### **HumeLink Stage 1 (Early Works) Contingent Project Application**

The National Parks Association of NSW (NPA) wishes to make this submission on TransGrid's Contingent Project Application for HumeLink Stage 1 (Early Works), 5 April 2022.

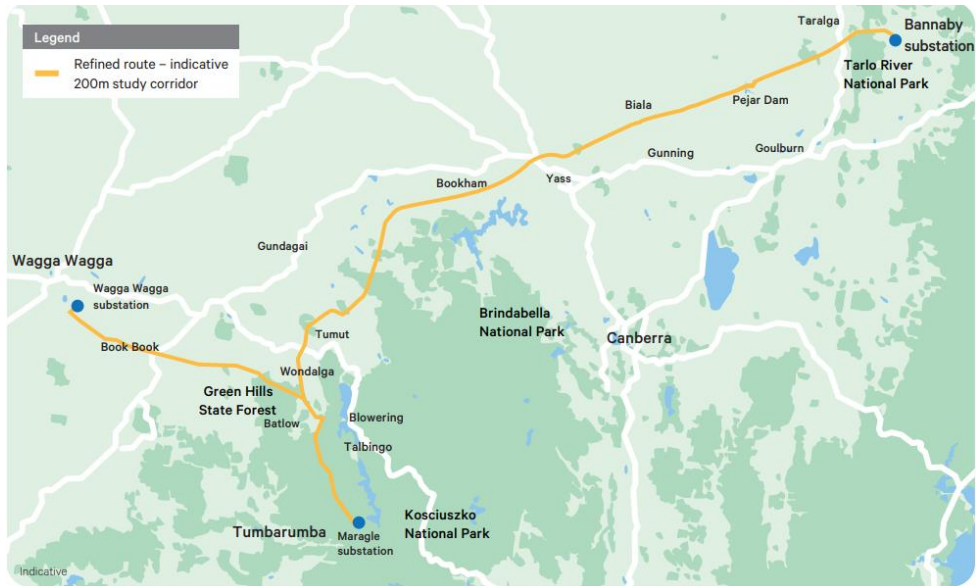
Option 1C-new is the cheapest credible option and has the superior net benefit, albeit negative. Option 2C is also a better option than 3C from an electrical perspective for the NEM.

When TransGrid's net benefit estimates are adjusted for the sensitivity scenarios and exclusion of competition benefits, Option 1C-new has a \$149m superior net benefit compared to Option 3C.

The comparative costing of Option 1C-new and 3C seems to be in error due to the significantly lower cost/km for the Maragle to Wagga Wagga section. If so, the comparative net benefit of Option 1C-new to 3C increases even more.
